Subject: U-2579 D, E,& F Request for Modification to Individual Section 404 and Section 401 Water Quality Certification

Subject: **Request for Modification to Individual Section 404 and Section 401 Water Quality Certification** for the Winston-Salem Northern Beltway from US 52 to US 311 (New Walkertown Road), Forsyth County. Federal Aid Project No. NHP-0074(213), TIP Nos. U-2579D, E& F. Division 9.

Permit Impact Site Modifications

| PROJECT REFERENCE NO. U-2579D, E & F | | SHEET NO. 23 | |

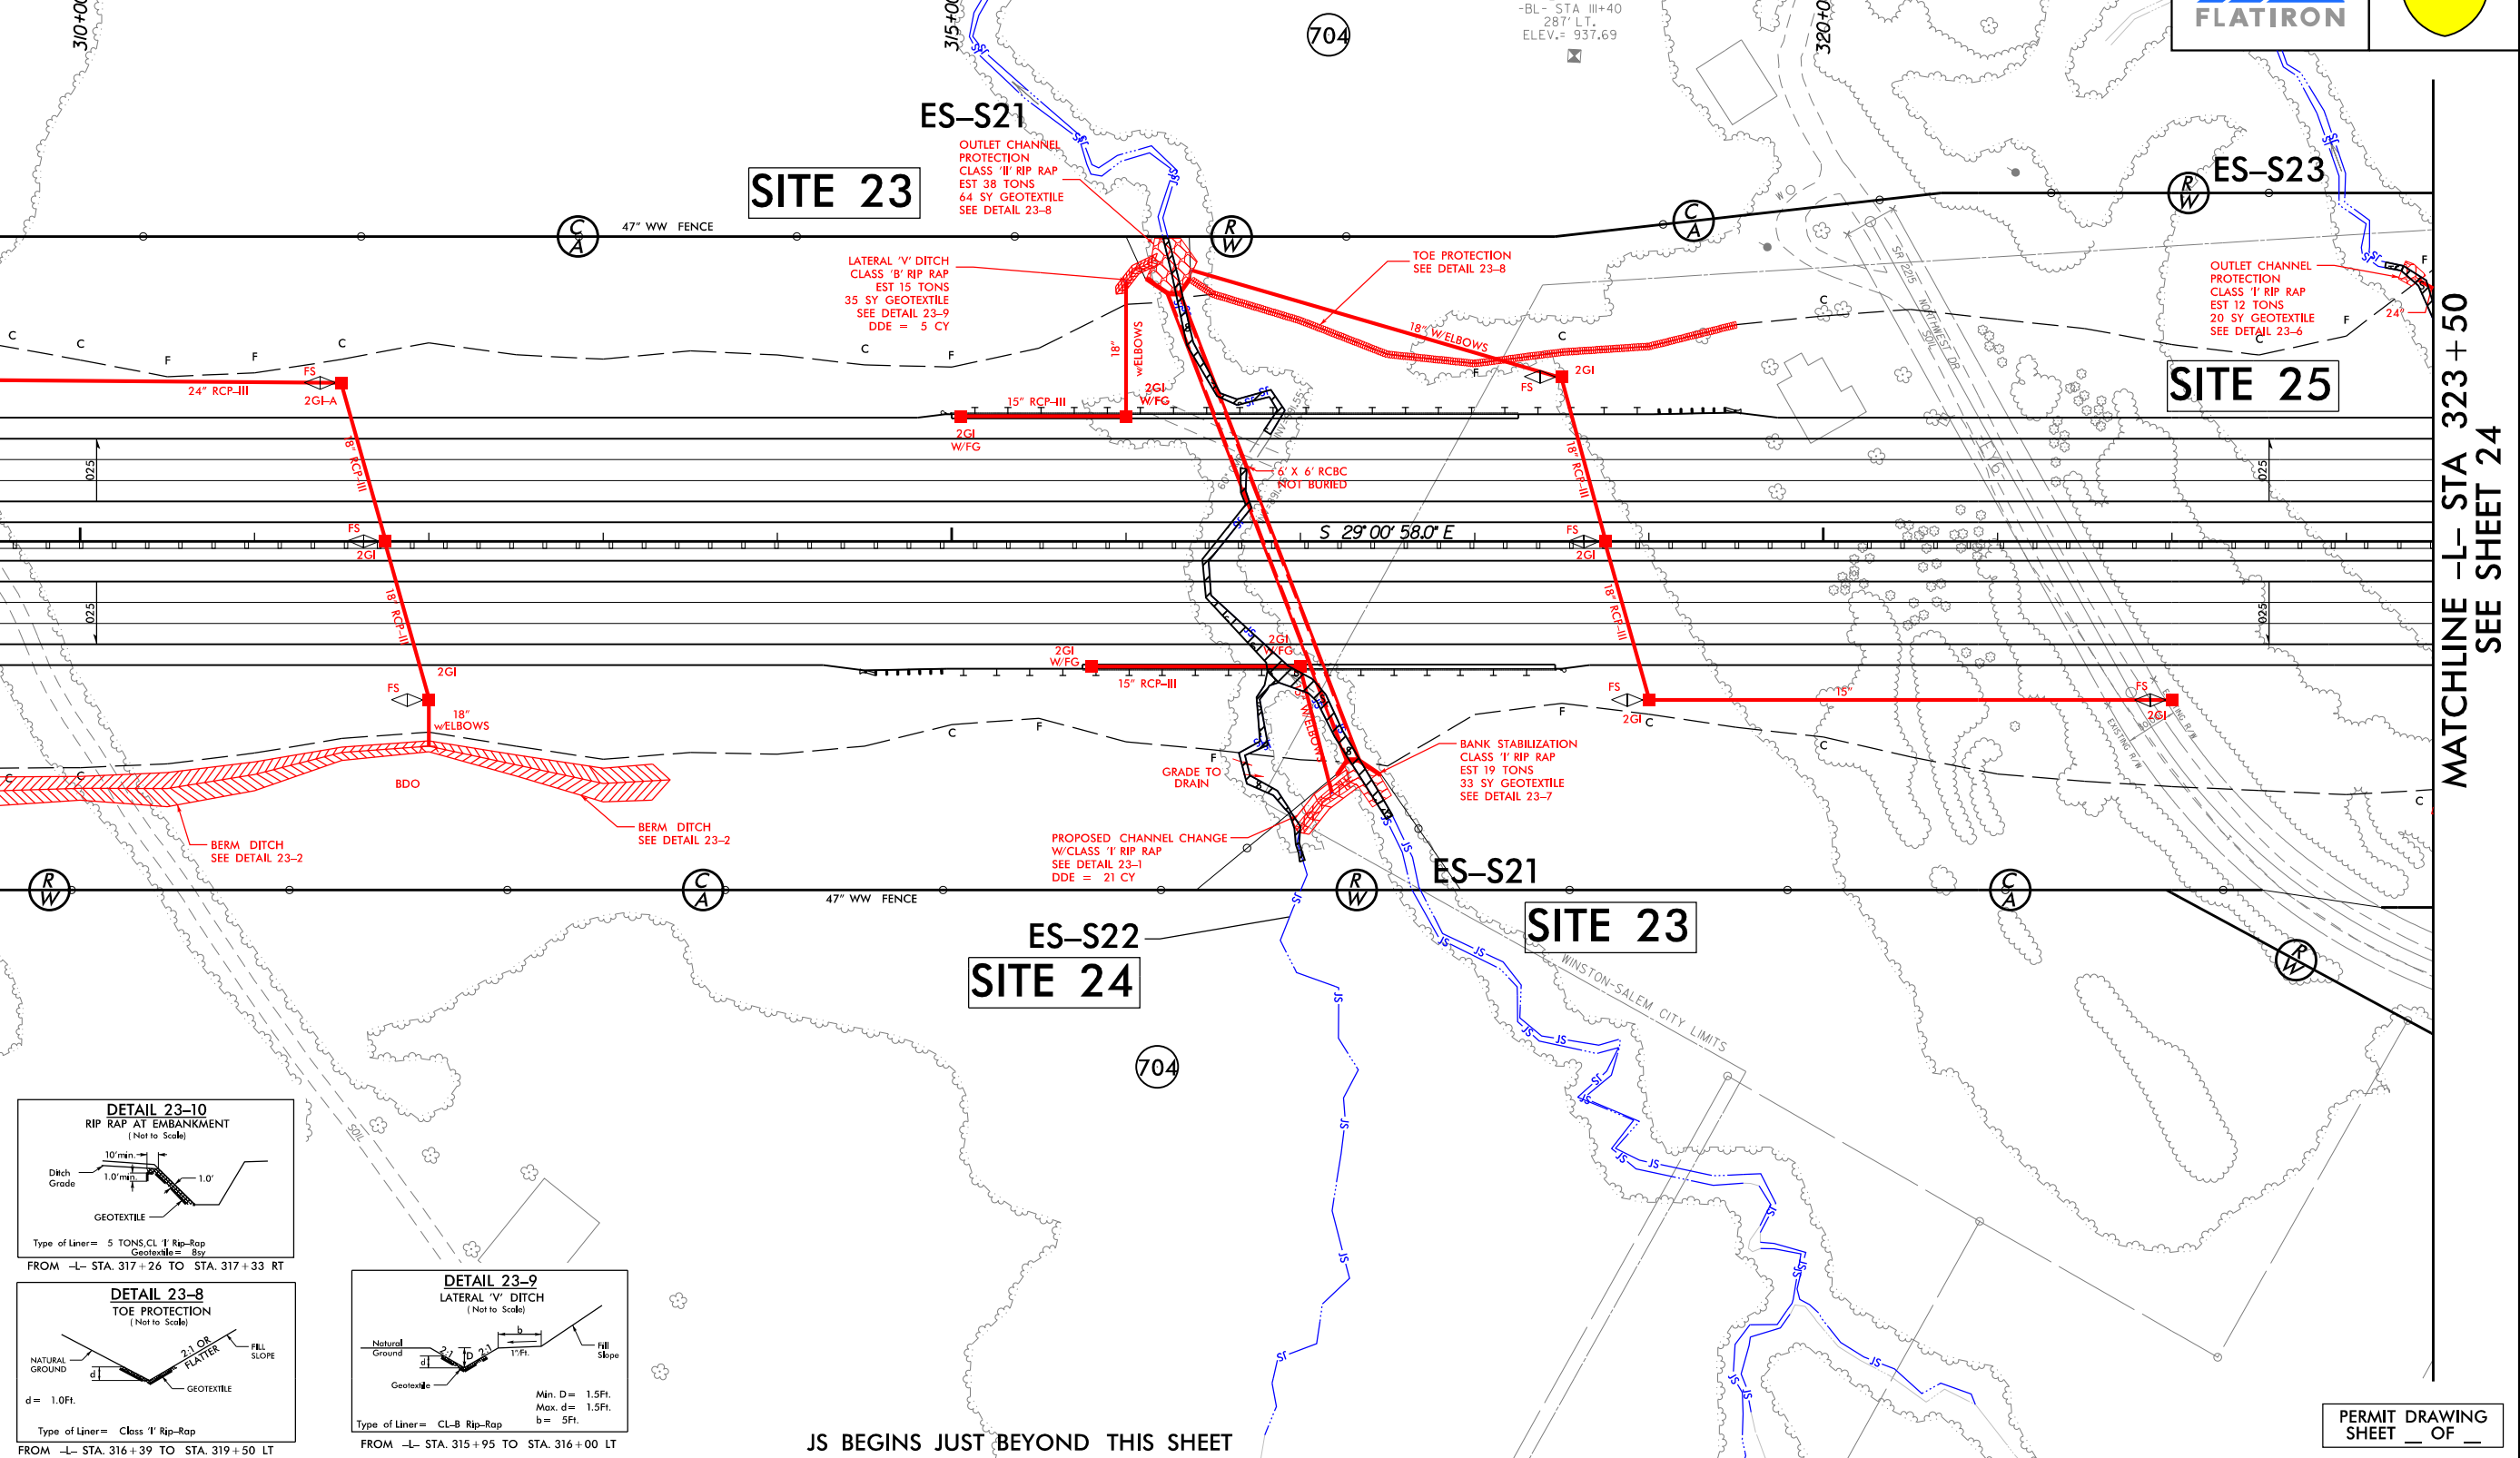
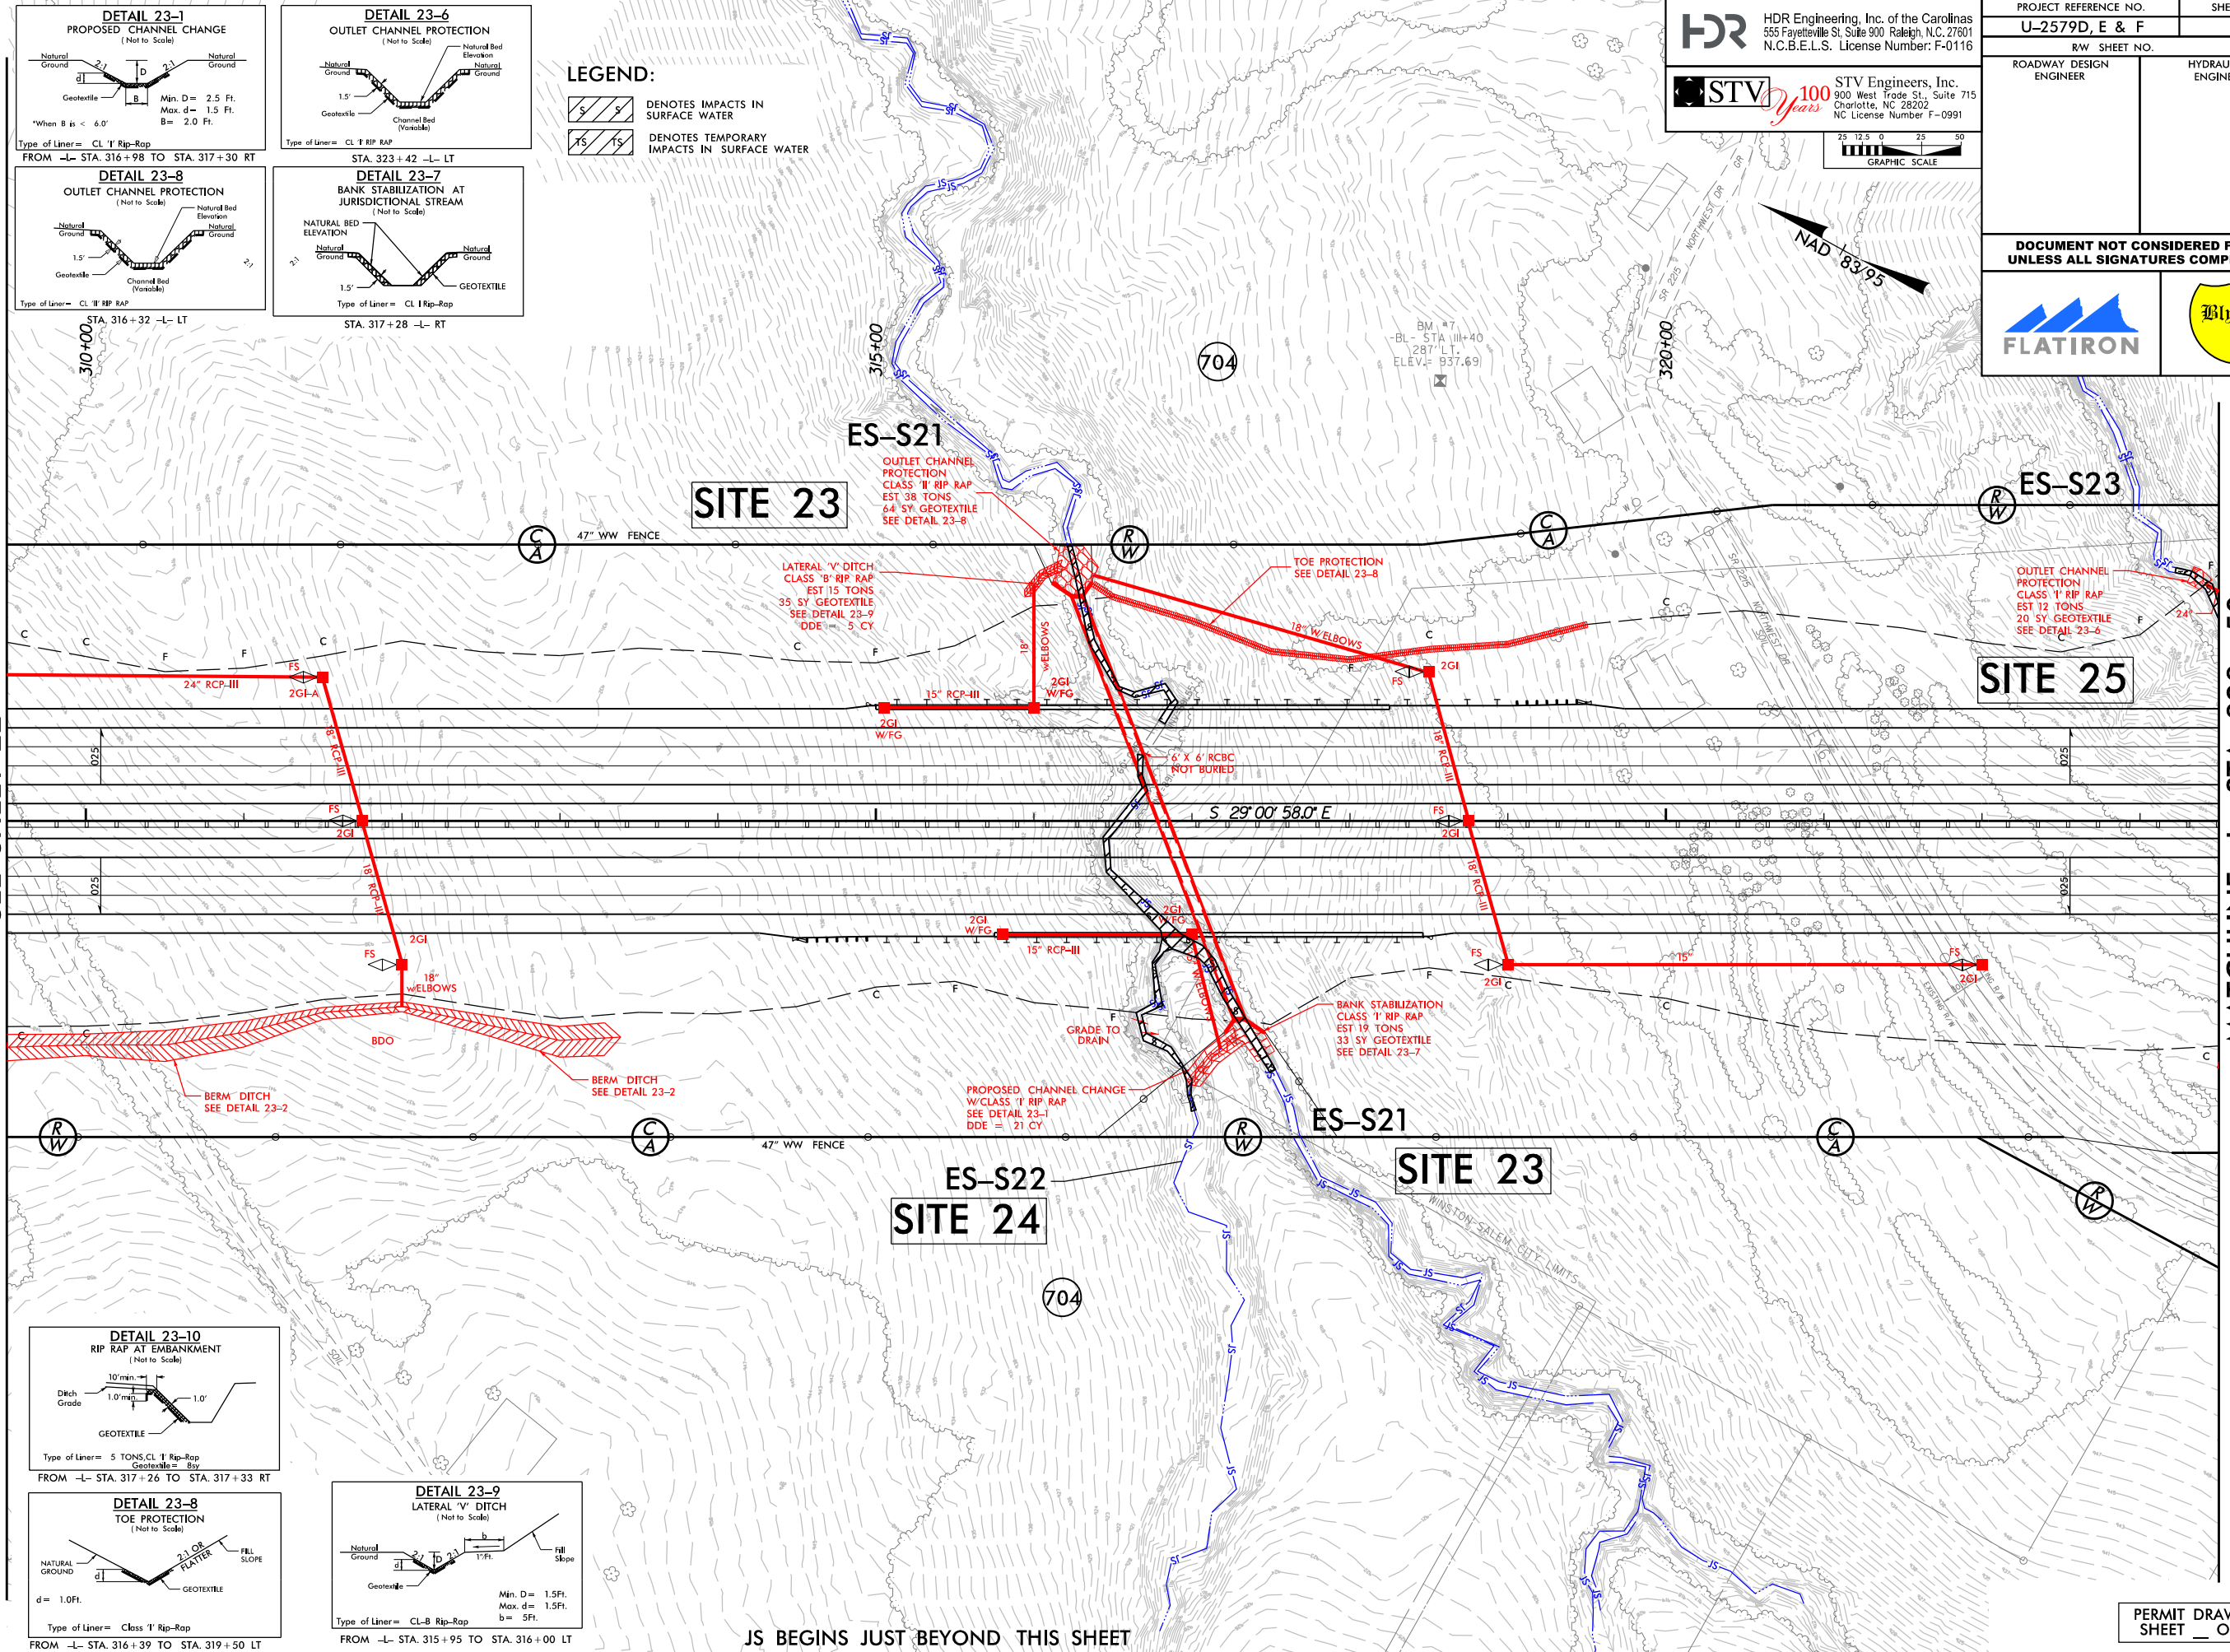
Site 23 (Sheet 23): Site 23 impacts changed as a result of the final design of the 6x6 RCBC in which the culvert length was increased from preliminary plans. When reviewed with the previous modification the new culvert length resulted an increase in permanent impacts by 15 linear feet for the RCBC and by 2 linear feet for bank stabilization. The temporary impact at this site was reduced by 11 linear feet. There will be a total of 363 linear feet of impact due to the RCBC, 28 linear feet of bank stabilization, and 10 linear feet of temporary stream impact at Site 23.
